NRC INFORMATION NOTICE NO. 89-29: POTENTIAL FAILURE OF ASEA BROWN BOVERI  
CIRCUIT BREAKERS DURING SEISMIC EVENT

Subject: Slow Close Lever Rebound Spring for  
ABB Power Distribution K-Line  
Electrically Operated K-225 through  
K-2000 Circuit Breakers  
(Part 21 Report)

FIELD INSTALLATION OF: Slow Close Lever Rebound Spring  
Electrically Operated K-225 through  
K-2000 Circuit Breakers.

FIGURE 1

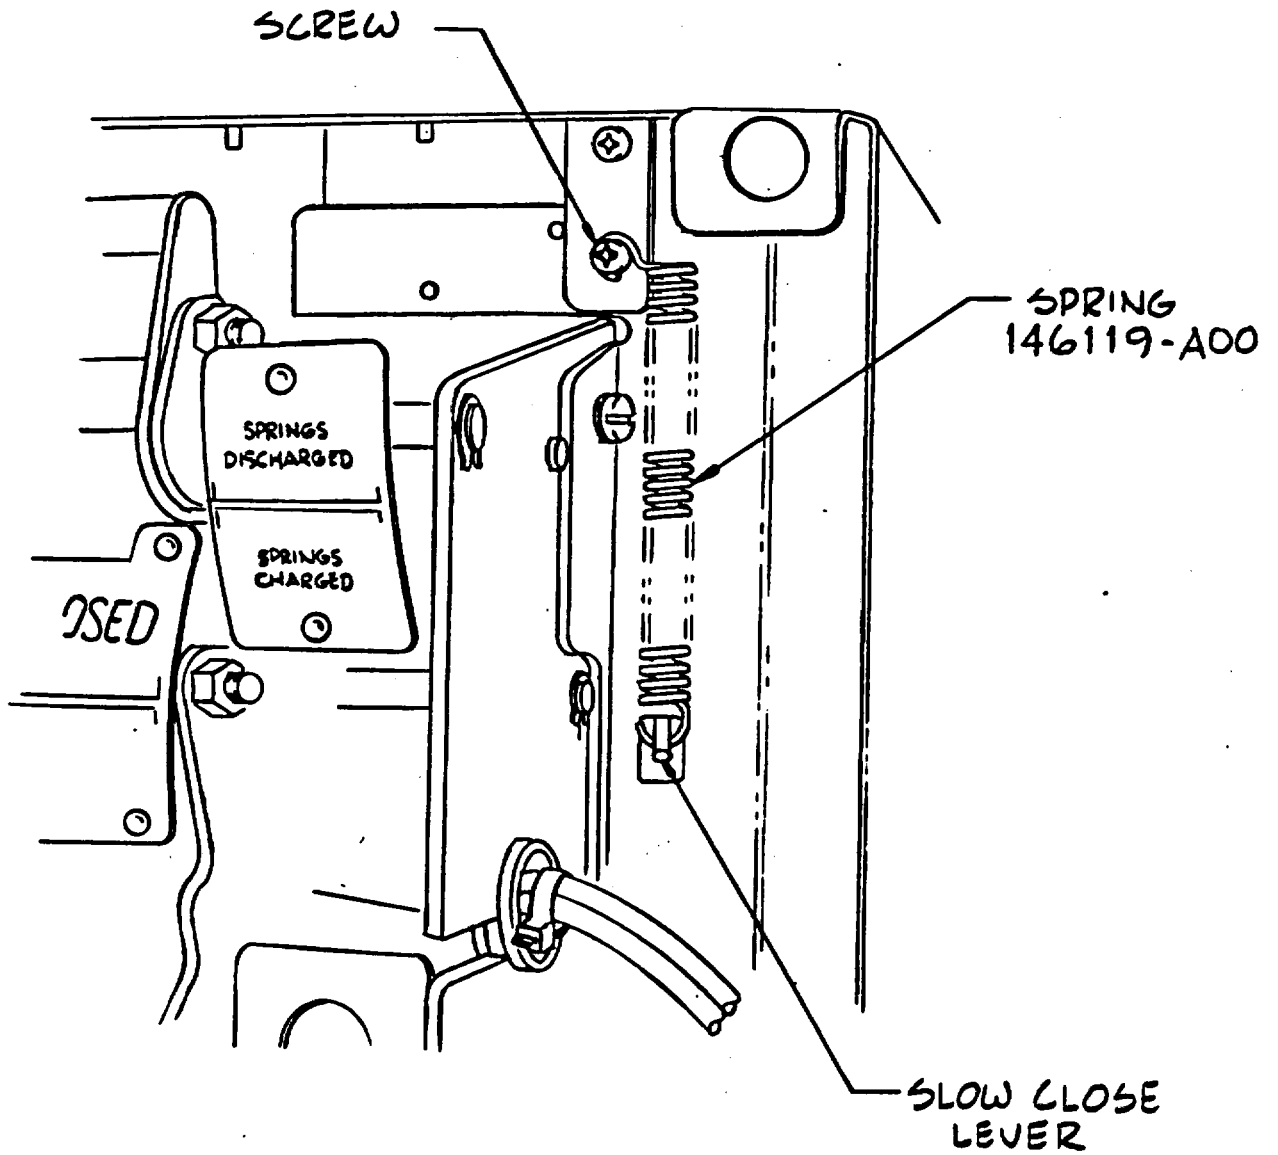
5. Locate also the upper right Phillips pan head screw which attaches the black housing to the silver-grey front frame. Loosen this screw approximately two turns. See Figure 1.

6. Hook on end of spring 146119A00 over the loosened screw. Stretch the spring so that the hook can be slid down on the slow close lever.
7. Retighten the screw to secure the spring at its top. This completes the spring installation.
